Connecting Rod Update for 2007-2016 Cummins/Dodge 4.5 & 6.7L Diesel Engines

The AERA Technical Committee offers the following information regarding a connecting rod update for the 2007-2016 Cummins/Dodge 6.7L diesel engines. There are multiple rods being used for these engines and one should not assume different casting numbers are interchangeable. There are several unique differences among the different rods that may or may not make interchangeable.

Connecting Rod Characteristics

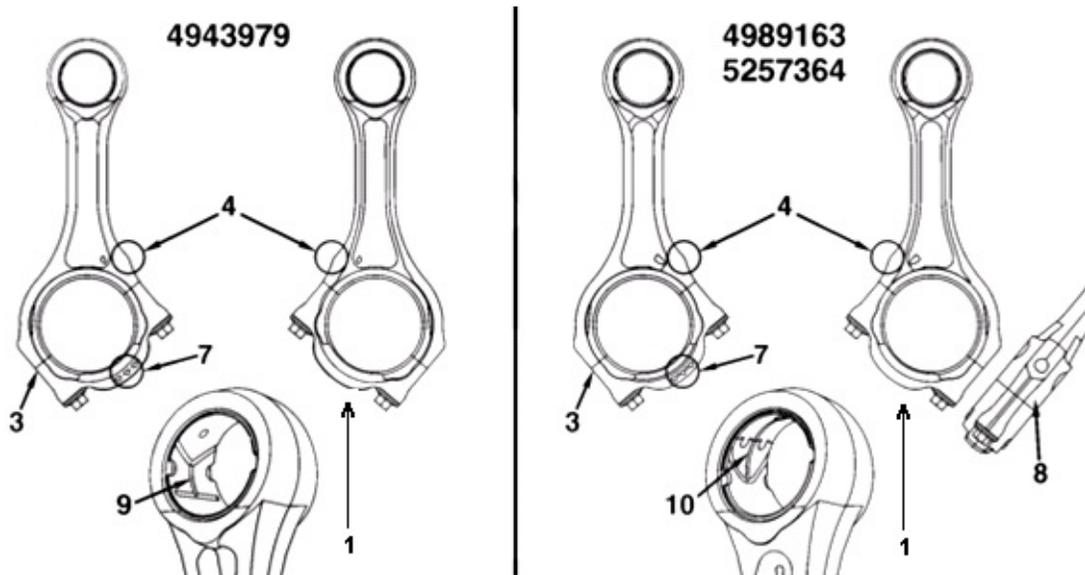
1. Balance pad
2. Machined surface (does not apply, refers to other B Series rods)
3. Non-machined surface
4. Bump or bulge
5. Smooth (does not apply, refers to other B Series rods)
6. Single dimple (does not apply, refers to other B Series rods)
7. Three dimple
8. "TA LF" or "7364"
9. Oil grooves in leaded pin bushing Part #4891178
10. Oil grooves in lead-free bushings Part # 4983518 and 5257363. (These bushings are not serviceable)

Due to weight differences that will result in engine vibration, special consideration must be given to mixing certain connecting rods in a single engine.

- In engines built before January 1, 2010, with connecting rod Part #4935880, 4943979, 4989163, and 5257364: these rods may only be mixed with each other.
- In engines built after January 1, 2010, with connecting rod Part #4989163, and 5257364: these rods may only be mixed with each other.
- Connecting rod Part Number 3954658 and 3971212 may only be mixed with each other.
- Connecting rod Part Number 4891176 must never be mixed with any other connecting rod.
- Connecting rod Part Number 3942581 must never be mixed with any other connecting rod.
